ADDENDUM NO. 4  
TO THE CONTRACT DOCUMENTS  
for the construction of  
**McCROSKEY ISLAND WWTP EXPANSION**

Date: July 27, 2022  
Project No.: C6A08007

**City of Sevierville, TN**  
**McCroskey Island Wastewater Treatment Plant**

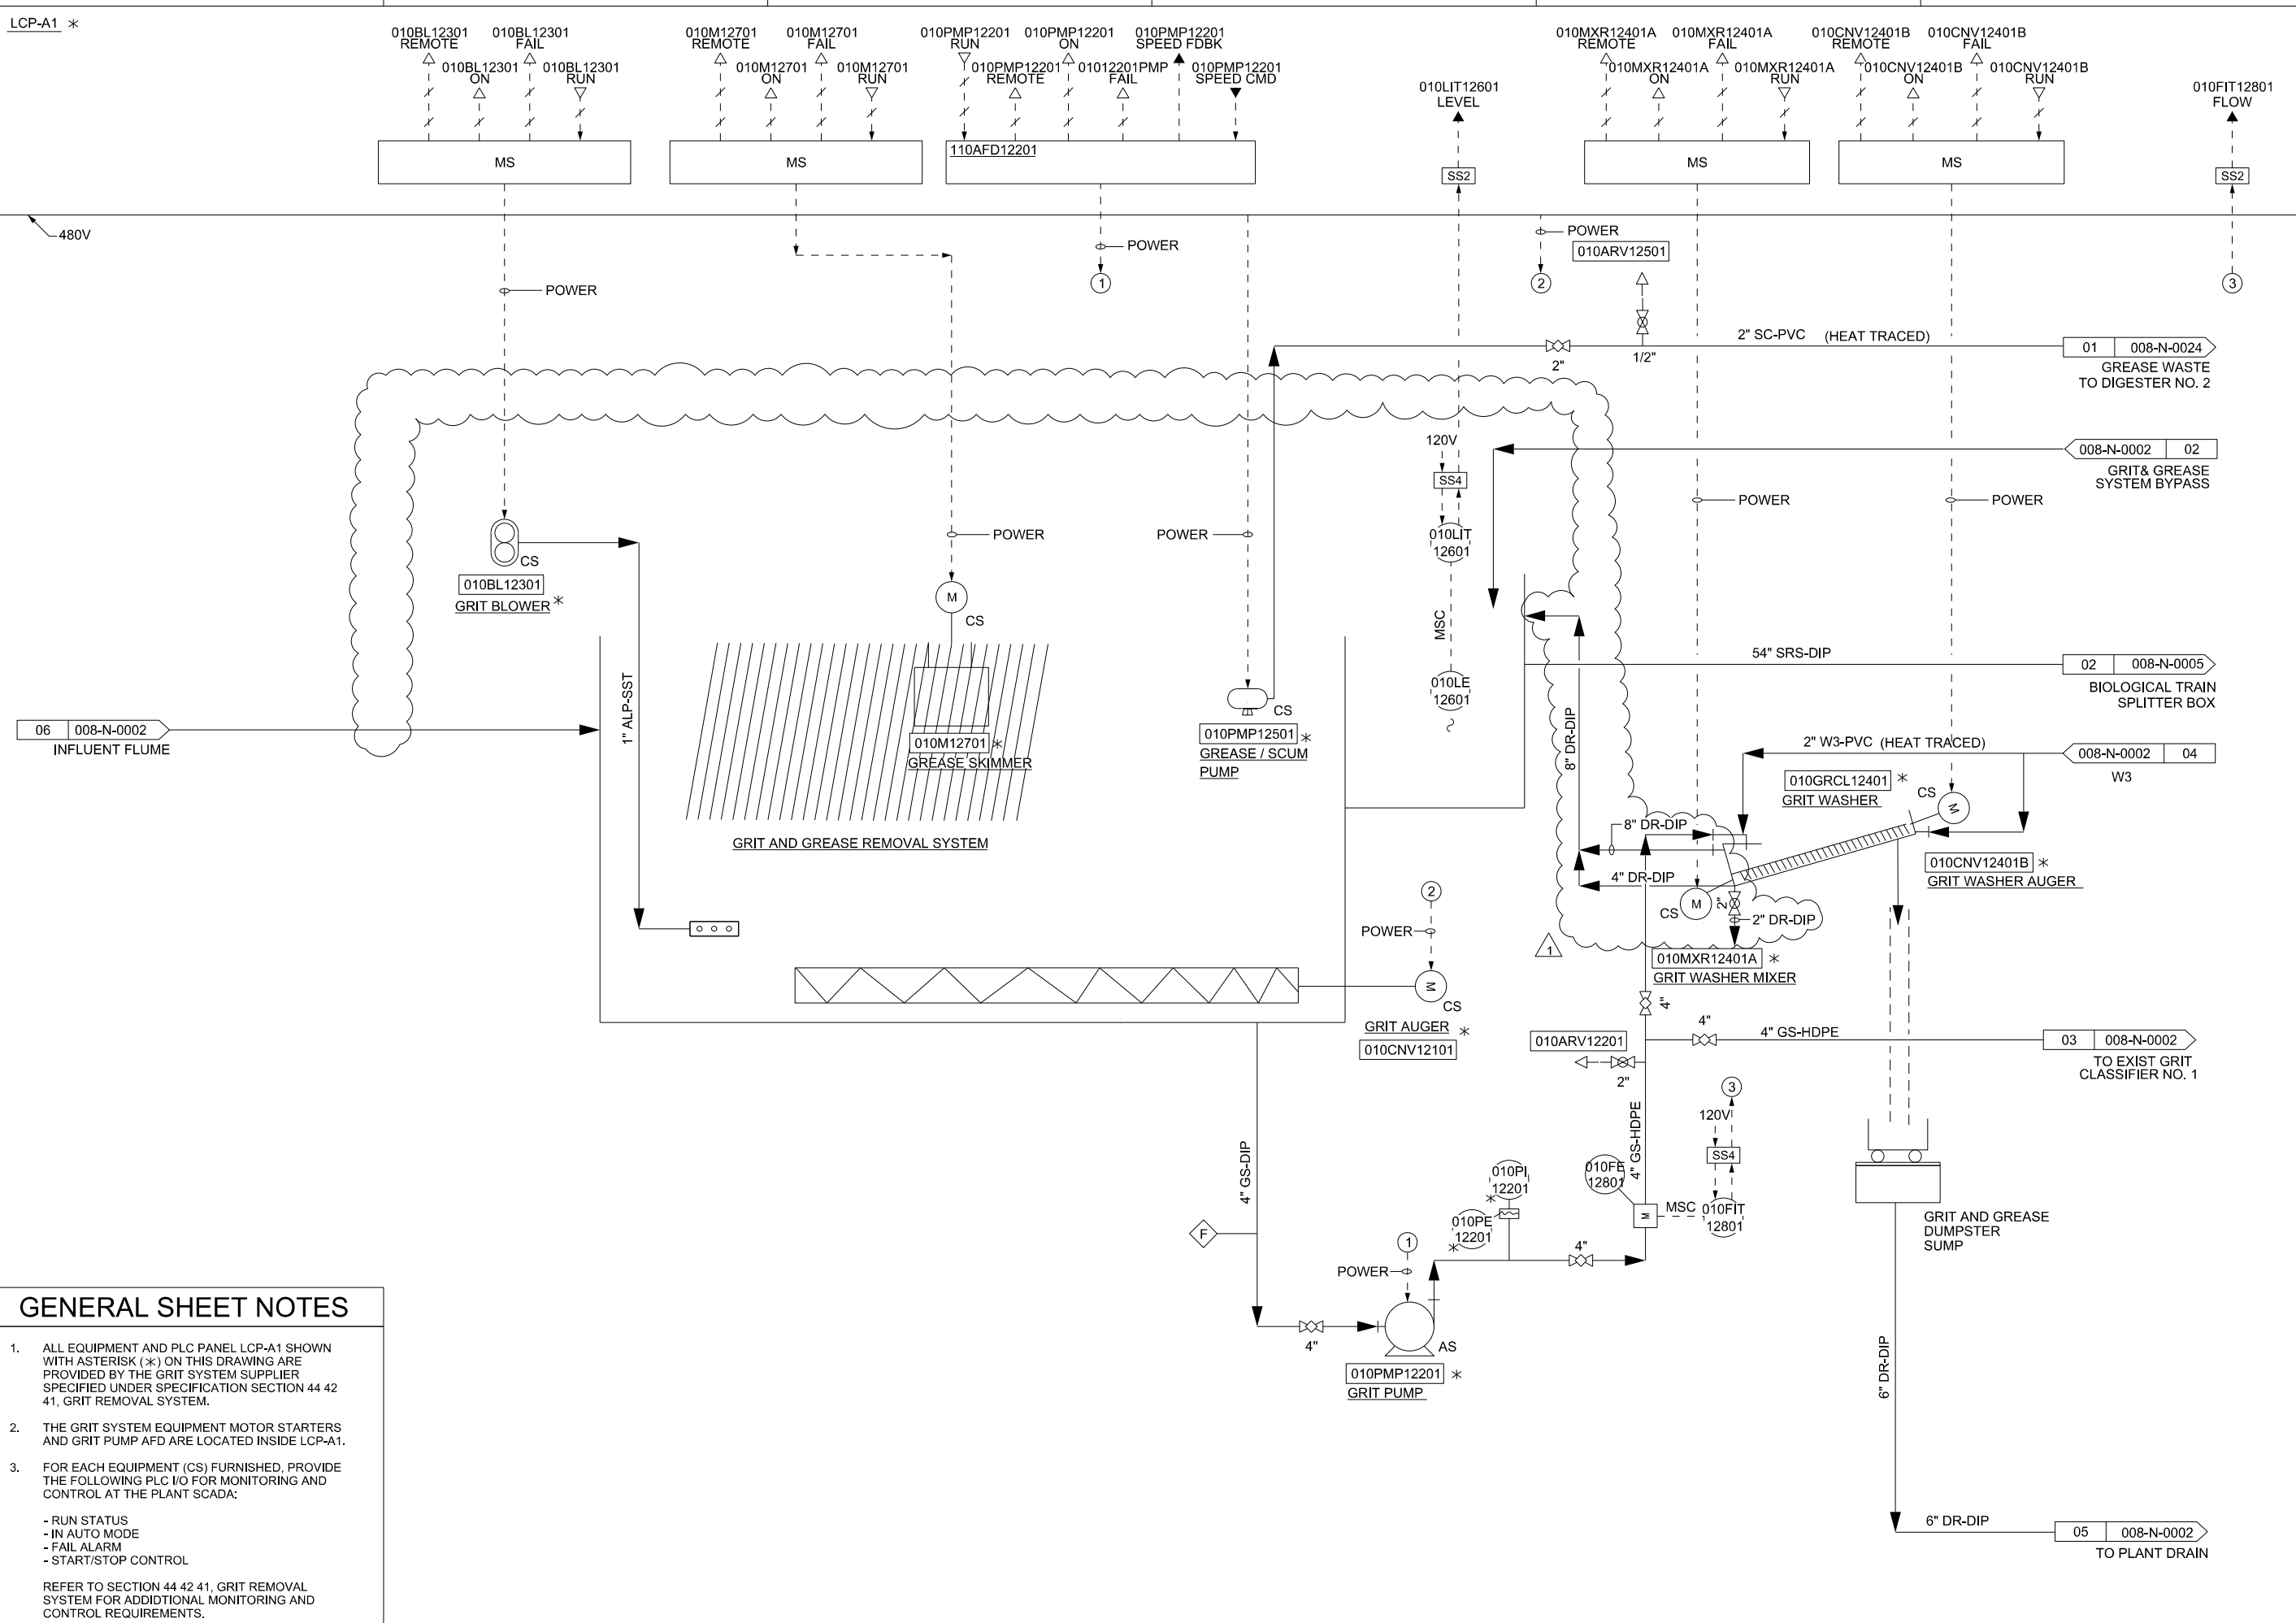
5. **Question 5:** Sheet 008-N-003 indicates that there should be 3 effluent connections to the grit washer. The drawings indicate 2 connections. Please clarify which is correct.

1. 005-C-9004: On detail 3215-260 REPLACE the asterisk (\*) on the base course depth dimension with 8”
2. 008-N-0003: REPLACE drawing in its entirety with the attached.

**Response:** The grit washer has 3 effluent connections: 8"DR-DIP, 4-DR-DIP, and 2"-DR-DIP. The 2"DR-DIP and ball valve are shown on 010-D-3001, but not labeled – see PART 4 DRAWINGS. The grit washer outlet connections are also noted in Section 44 42 41 Grit Removal System, Paragraphs G.3.d, G.4.b, and G.4.c.
